INDIAN POINT NO. 3 NUCLEAR POWER PLANT

May 18, 1979  
KC-IP-4796

Docket No. 50-286  
License No. DPR-64

Subject: Information Requested  
on Attached Letter

**SERIES 44 STEAM GENERATOR**

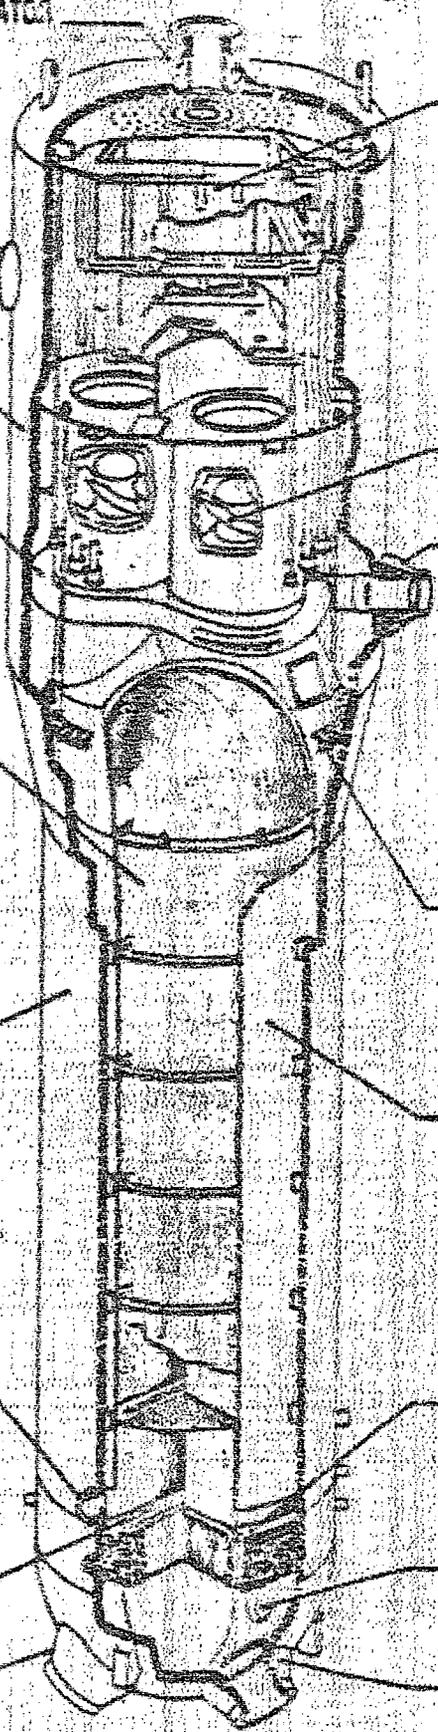
The Westinghouse Model 44 steam generator is a vertical shell and U-tube evaporator, with integral moisture separating equipment. The Westinghouse steam generator is a saturated steam generator with a maximum moisture carryover of 0.25%. The feedwater is injected via a feeding into the downcomer where it mixes with recirculated water and water removed by the moisture separators. This makes up the total feed flow to the steam generator. This model steam generator has 44,430 square feet of heat transfer area. This heat transfer area is made up of 3,260 U-tubes that are 7/8 inches outside diameter with a .050 inch thick wall.

A schematic diagram of the Series 44 steam generator is shown on the following page.

At 52% (normal operating level) in the steam generator, there is 78,500 pounds of water.

At 30% (Low Level MisMatch Trip) in the steam generator, there is 65,200 pounds of water.
